Presentation from the Sierra Club Canada Foundation

Canadian Nuclear Laboratories (CNL)

Application from the CNL to amend its Chalk River Laboratories site licence to authorize the construction of a near surface disposal facility

Supplementary submission for the NSDF
licensing hearing

NSDF Project initiated without knowledge of wastes to be disposed of

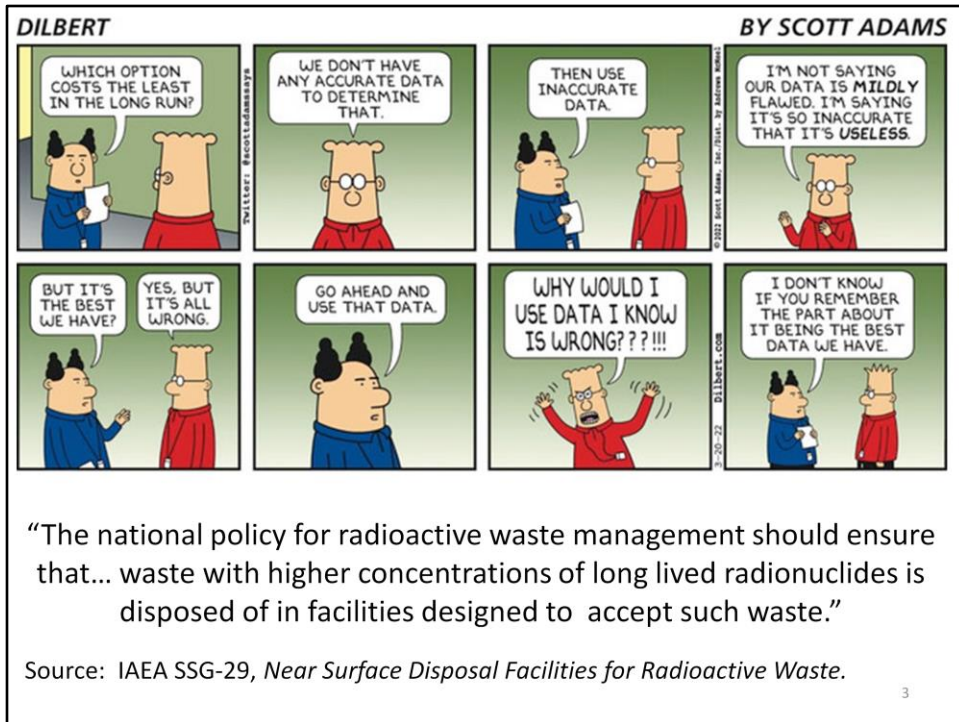
CNSC’s Environmental Assessment Report cites IAEA Safety Guide SSG-29 in claiming that “the NSDF site selection process used structured criteria and methodology and is in alignment with the applicable standards.”

How is this possible, when Appendix 1 of SSG-29 says the first two stages in siting a disposal facility are a conceptual and planning stage and an area survey stage? Is it not true that CNL skipped both of these stages?

Alternative means

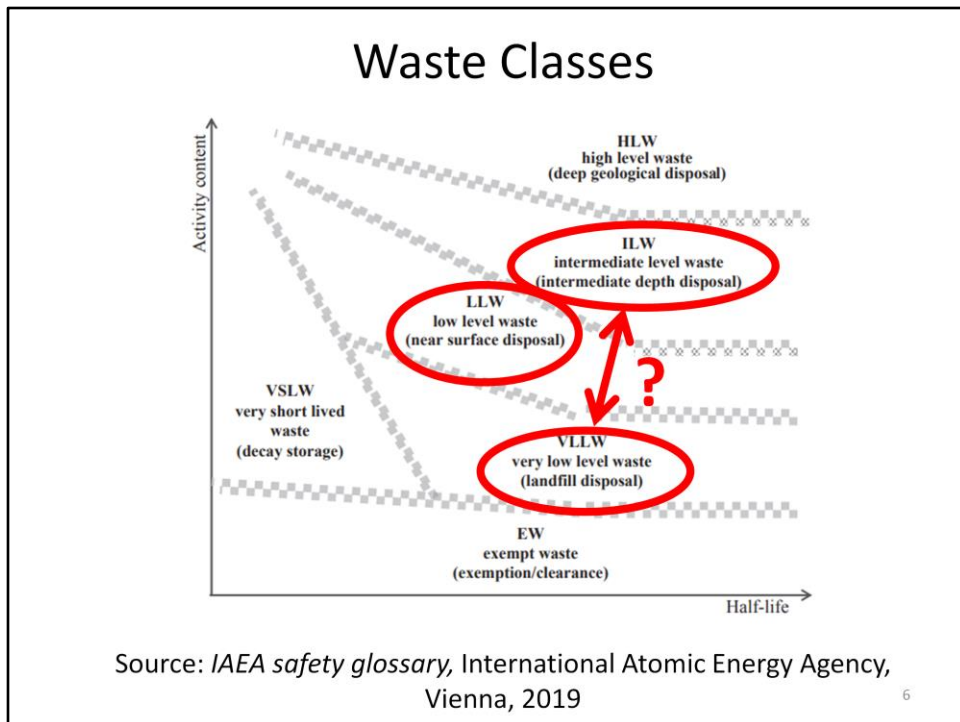
The CNSC is assessing the NSDF under CEAA 2012. This requires consideration of technical and economic feasibility and environmental effects of alternative means. The EA report says that CNL only fully assessed a mound and a deep underground repository. Cost of alternatives was “not factored into CNSC staff’s review.” Why did CNSC staff not consider economic feasibility of alternative facility types?
